From: Tim Townsend [redacted]
Sent: 01 November 2021 08:17
To: Tilly Whishaw [redacted]
Cc: Chris Pratt [redacted] Michael Eastham <Michael.Eastham@arun.gov.uk>
Subject: RE: BN/119/21 - Angels Nursery, Yapton Road, Barnham

Cc: Chris Pratt [redacted]
Subject: BN/119/21 - Angels Nursery, Yapton Road, Barnham

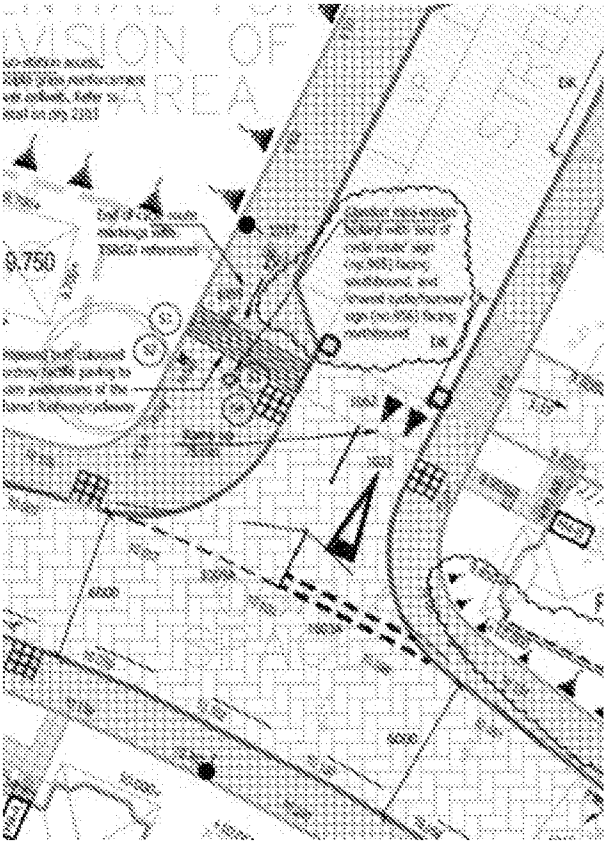
The only apparent outstanding point seems to be with the tie-in point of the cycle/footway as shown below (extract from plan showing how you currently propose things) and as such, I thought it maybe more expedient to approach you directly to try to resolve things:

As shown, it will be particularly difficult for a cyclist to enter or leave the road without overriding the corduroy paving, the tactile paving and part of the ramp. To rectify this would require the corduroy and tactiles being moved southwards and markings provided on the path and – if possible and agreeable with our S38 engineer - on the road away from the ramp. On earlier versions of the internal layout the entry and exit point for the path was further west around the corner and away from conflict points so this might be another option for you/your engineers to consider.

I'd be grateful if you would look into this and provide me with an amended arrangement as soon as possible, please.

I can confirm that all is now good from the highways point of view and my formal response to the application was sent to Michael last week confirming this.

Thanks for your email on this. I believe that Chris also discussed this directly with Stephen at Gyoury Self who has sent through the attached updated drawing. Could you confirm that this is now acceptable?
